July 8, 2021

Mr. Tom Reetz
Senior Planner, Development Department
City of Stuart
121 SW Flagler Avenue
Stuart, FL 34994

RE: Kanner CPUD – Response to 1st Reading Conditions of Approval

Previous Site Plan:

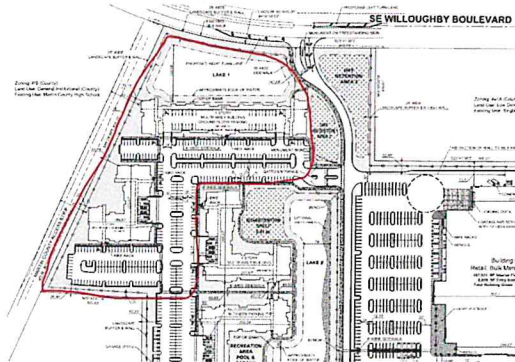
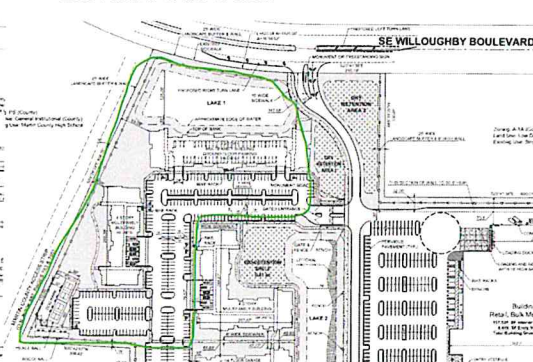
1. 5% Density Reduction.

Total multi-family dwelling units were reduced by (20) one-bedroom units bringing the new total to (378) units versus the previous (398) units. The change occurred in the northeastern portion of the site at buildings 3 and 4 by actually revising the building design to facilitate not only the reduction in units/density but an increase in landscape area and open space provided; Refer to revised site plan provided;
